# UNITED STATES PATENT AND TRADEMARK OFFICE

| APPLICATION NO.   | FILING DATE | FIRST NAMED INVENTOR | ATTORNEY DOCKET NO. | CONFIRMATION NO. |
|---|-------------|----------------------|---------------------|------------------|
| 10/622,784  | 07/21/2003  | Kenji Utsunomiya     | 402716/SOGA         | 4261             |

| <b>Office Action Summary</b> | <b>Application No.</b><br>10/622,784 | <b>Applicant(s)</b><br>UTSUNOMIYA ET AL. |  |

Paper No:04152005  
Application No:10/622784  
Filing Date: July 21,2003

Fig. 1

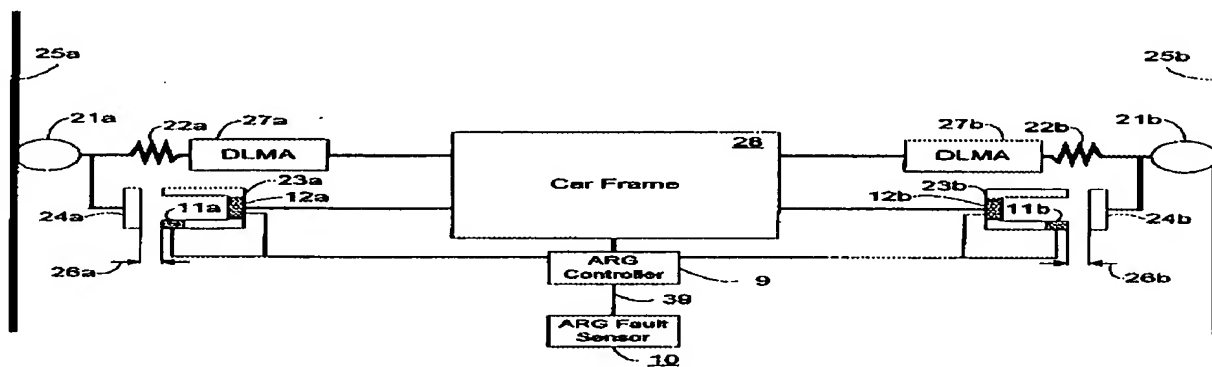
Jamieson et al teaches in figures 1-4, an elevator active guide fault sensor system.

- 1) A vibration magnet 23a,23b contains sensors 11a,11b which control actuators 27a,27b to center the car 28 in the shaftway horizontally. A detection sensor 10 compares the sensor values. If the values fall above a limit 51 the actuator is shut-off 52.
